**DOCKET NUMBER 50-483
CALLAWAY PLANT
UNION ELECTRIC COMPANY
RESPONSE TO REQUEST FOR ADDITIONAL INFORMATION
ON REVISION TO TECHNICAL SPECIFICATION 5.5.9
"STEAM GENERATOR (SG) TUBE SURVEILLANCE PROGRAM"**

**REQUEST FOR ADDITIONAL INFORMATION
REVIEW OF THE CALLAWAY PLANT APPLICATION
FOR REVISION TO TECHNICAL SPECIFICATION 3/4.4
TAC NUMBER: MB1214**

Figure R6-37

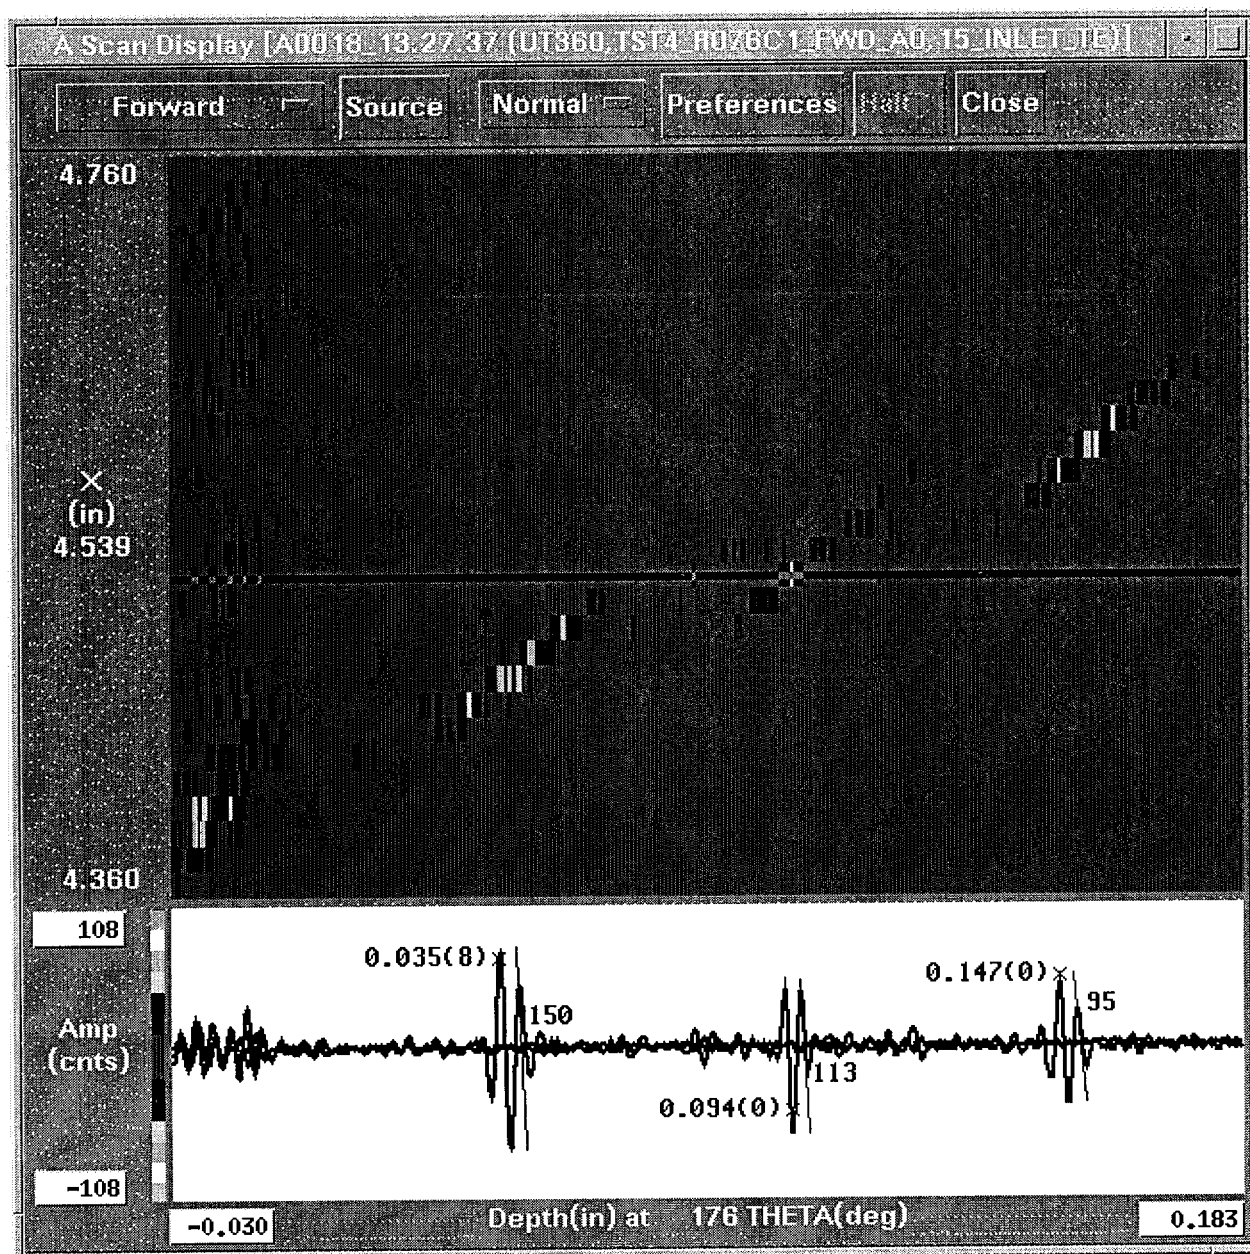
RAI # 6. During the meeting, FTI indicated that PWSCC detectability in the sleeve could be inferred from the ID notches in the UT calibration standards and the data sets containing pits. It is not clear to the staff how detecting EDM notches in the calibration standards or another degradation morphology such as pits would infer an ability to detect tight flaws such as PWSCC. Explain the basis for the statement that sleeve PWSCC ID defects will be detected, and the resulting sensitivity and POD, since the peer review (ETSS # 98404) only covers volumetric defects. Please provide additional discussion or, preferably, additional data to support the claims of the capability of the technique to detect PWSCC in the sleeve. (Question from the 6/7/01 meeting held with UE, FTI, and the NRC staff)

During the fatigue cycling, fatigue cracks developed in the sleeve wall at the inner diameter crack site as well as at the outer diameter crack site. The post fatigue portion of this presentation will show the return of the full skip reflection at the inner diameter crack location as well as the increase in the FSN result for the outer diameter crack.

This is the pre-sleeve C-Scan plot of the ODSCC circumferential crack in tube TST4-076-1. The outer diameter crack extent (length) can be estimated from the C-Scan plot as $(261 - 95)$ or 166 degrees. The plot shows the presence of a half skip response, a one and one half skip response and a considerable amount of full skip and two skip reflections.

This is the post sleeve (pre-fatigue) C-Scan plot of the ODSCC circumferential crack in tube TST4-076-1. The outer diameter crack extent (length) can be estimated from the C-Scan plot as (261– 96) or 165 degrees. The plot shows the presence of a half skip response, a one and one half skip response and some full skip reflections between the 170 degree and 220 degree locations.

This is the post fatigue crack C-Scan plot of the ODSCC circumferential crack in tube TST4-076-1. The crack extent (length) can be estimated from the C-Scan plot as $(261 - 94)$ or 167 degrees. The plot shows the presence of a half skip response, a one and one half skip response and the return of the full skip reflections.
